APPENDIX B

CHOOSING BY ADVANTAGE

VALUE ANALYSIS / CHOOSING BY ADVANTAGES
November 30 – December 3, 2004

BLUE RIDGE PARKWAY
BLUE RIDGE PARKWAY REGIONAL DESTINATION VISITOR CENTER
PMIS – 081354

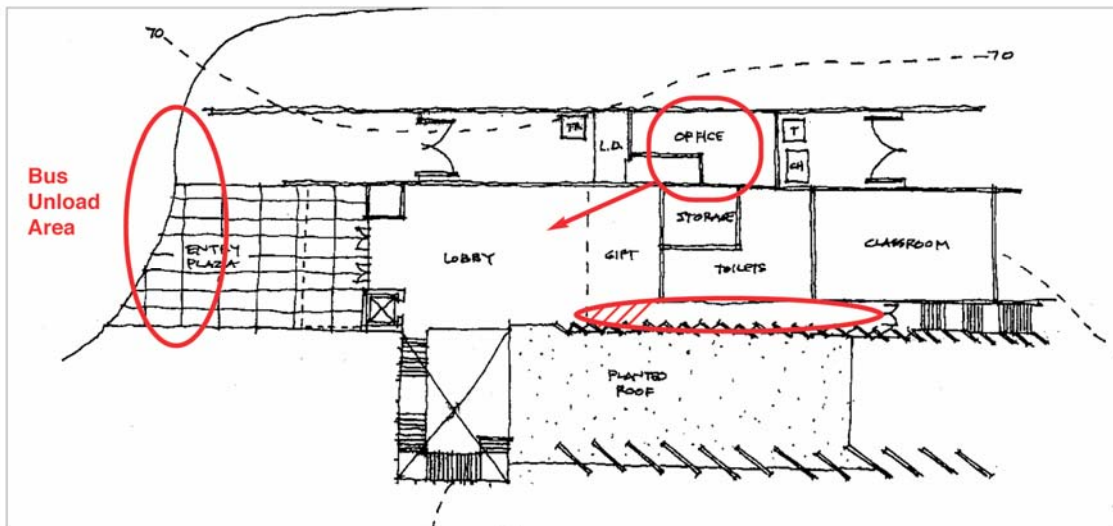
- **Entry Plaza**
 - Consider extending (fanning out) plaza area to include the loading dock zone to allow two (2) buses to park and unload at the same time.
 - Covered entry is a good element. Although it was suggested that it might serve as the outdoor sheltered program space, the close proximity to the entry doors makes this less desirable for this purpose. It is preferred to have a separate area.
- **Lobby**
 - The NPS office needs to be closer to the lobby as it has a strategic relationship with the NPS information desk. It is also beneficial for NPS staff to be able to go from the office into the exhibit space, especially if staff is bringing interpretive support materials out, to interact with visitors.
 - NPS information desk should have access to exhibit space. It is preferred to have NPS and the visiting public on the same floor level, or within easy visual contact.

- The gift shop near the entrance and lobby is good, since the NPS information desk also has to serve as cash and wrap area for gift shop merchandise.
- **Overall Flow**

- The flow sequence past the gift shop and toilets to access the classrooms was not preferred. It is good to have the toilets in close proximity to the classrooms because the flow sequence is generally from the bus-toilets-classroom. However the narrow corridor will cause schoolchildren to be “stacked up” with some along the gift shop. This will make it more difficult for teachers to maintain control.

- Concern was addressed with this plan over the visitor spaces being located in the lower level and beyond direct contact with NPS staff.
 - With no primary exhibit on the upper level, the interpretive visitor experience is less effective in that this scheme does not use an interpretive strategy to aid circulation. There are few visual cues, unless the visitor looks into the stairwell. It would be important, in this scheme, to suspend something within the air space of the stairwell to draw visitor attention.

- **Elevator**
 - It was requested that the elevator be a suitable size to be able to accommodate rolling carts with supplies and some collections materials.

- **Toilets**
 - The team suggested it would be desirable to have extended or 24 hours access to the toilets.
- **Classroom**
 - It was considered a benefit if the classroom could be oriented so it takes advantage of windows or some view into the resource. It was considered to be of benefit if there was easier access from the classroom to the outdoor program space, trails or resource.

- **Green Roof**
 - The ability to use the roof top as an outdoor space was suggested. It would be planted with native plants. The team appreciated this additional space but felt it would mainly be used to interpret the LEED story and potentially xeriscapes. This does not directly support the interpretive and goals and storylines.

Alternate Plan A – Lower Level:

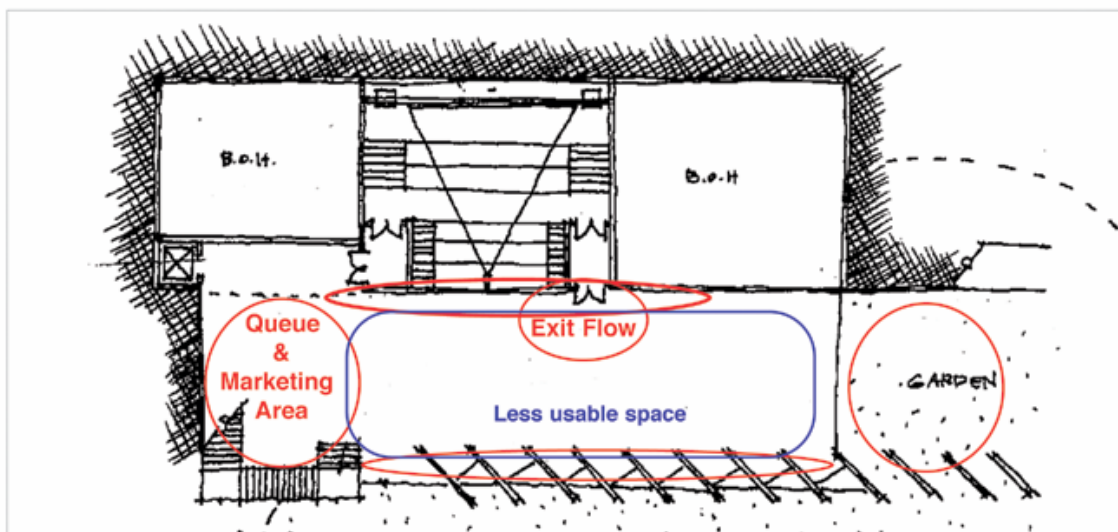
- **Overall Flow**

- Concern was expressed over the loss of exhibit space due to the flow of visitors exiting the theater into the middle of the gallery.
- Concern was expressed over the location of the mechanical/storage room, in that, eventually there is the movement of materials in and out of this space. That clear path makes some of the square footage of the exhibit gallery not usable.
- The space at the base of the stairs is very positive if used for the marketing center. The draw to the theater would provide a guaranteed flow through the marketing space, and the marketing space would become the queue and pre-show activity. Visitors exiting the theater can go back through the marketing area to find out more. This area can serve as an orientation to both the theater and Blue Ridge Parkway exhibit.

Alternative Plan B – Lower Level

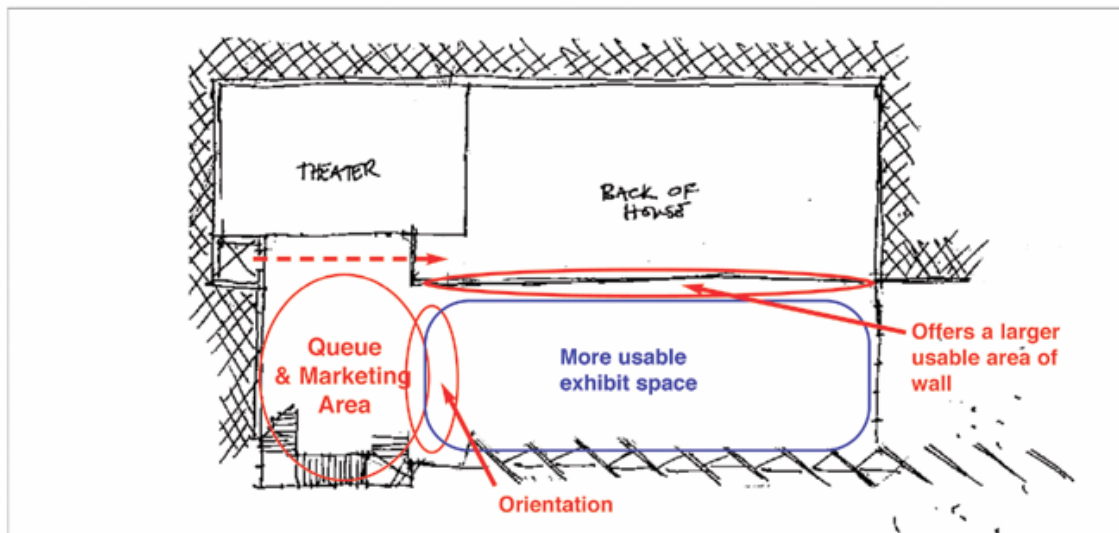
- **Overall Flow**

- In this alternate space study the theater is moved further to the left, and is directly opposite the stairwell. The marketing center becomes the gathering area for the theater. In this plan, the stairwell becomes critical because it needs to draw visitors downstairs to the interpretive experiences.

- This location draws visitors through the marketing area, as they enter and exit the theater or access the Blue Ridge Parkway exhibit.
- Locating the access doors to the back-of-house space outside of the exhibit area creates a usable, continuous wall and an uninterrupted exhibit space.
- **Elevator**
 - Direct flow from the elevator to the back-of-house space is good for the movement of curatorial materials, supplies or equipment.
 - If the elevator doors and stairs entering a space are in opposite corners, the storyline within that space cannot be linear. This ensures that visitors using the elevator have the same experience as those on the stairs.
- **Trombe Wall**
 - The trombe wall is less dominant in this space plan because there is more usable space within the exhibit area. The alcoves can provide unique interpretive spaces to be programmed.

Alternate Plan C - Upper Level

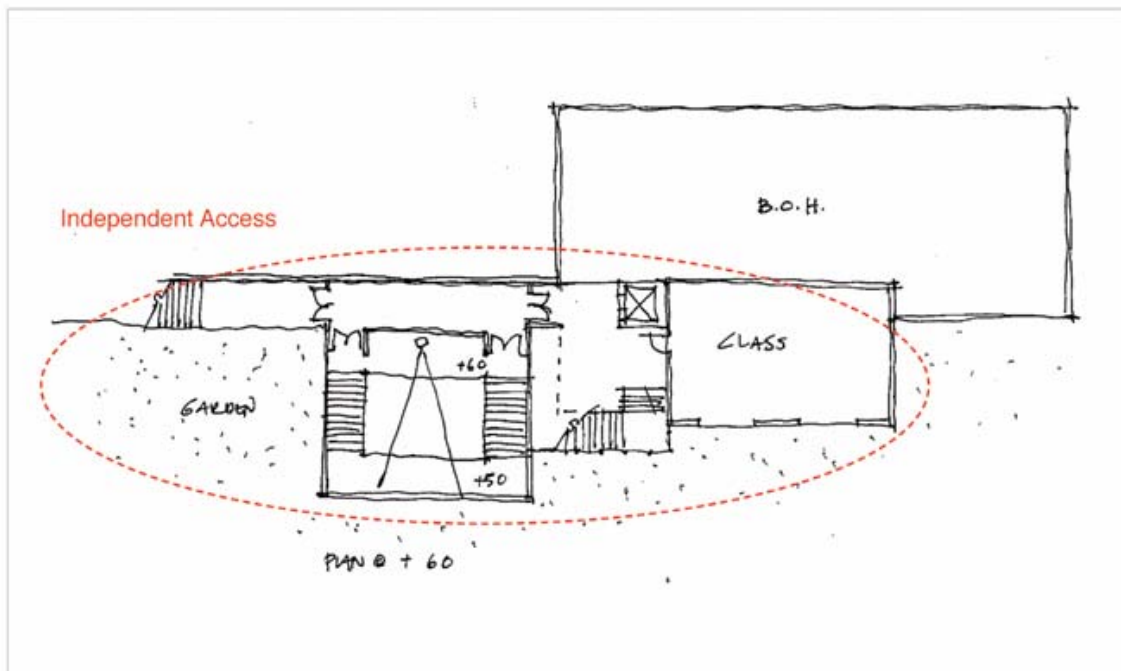
- **Entry Plaza**
 - This entry plaza will enable two (2) buses to park and unload at the same time. It also offers a larger area, away from the entrance doors to organize school groups.

- Access to the toilets without entering the building is good as it extends hours of usage. The plaza in this plan becomes the stacking zone for school groups using the toilets. This eliminates the stacking problem with alternate plans where circulation space is at a minimum. Consideration should be made to create more of a setback between the entrance doors and the toilets so the entry remains dominant. It is understood that this is conceptual.

- **Lobby**
 - This plan enables the NPS desk to have easy visual and physical access to exhibit spaces and gift shop.
 - It is important visitors make first contact at the NPS information desk. It is also important that there is no confusion between the NPS desk and the Marketing Center desk. Consider creating a separate office for the Marketing area which includes its information desk. This would also provide an alcove to display brochures in a less prominent area. The primary information delivery method in the Marketing Center is via touch-screen interactive stations.

- **Overall Flow**
 - This plan maximizes visitor flow between the lobby, marketing center and exhibit spaces. The unified space aids circulation enabling visual cues and interpretive messages to draw the visitors throughout the facility.

- The unified spaces enable the center to absorb people more freely in high use times.
 - This plan offers more effective use of space for the internal staff.

- It is better if the gift shop is an open space. The wall shown in this plan prevents a clear view into the gift shop and may encourage shoplifting. Also, an open format enables the shop to be expanded during peak visitation periods.

- **Elevator**
 - In this plan the proximity of the elevator to the stairwell is good. The point of entry for all visitors is the same which enables the interpretive experience to be linear or sequential if desired.

- A discovery cart program could be developed to maximize the use of this outdoor program space.
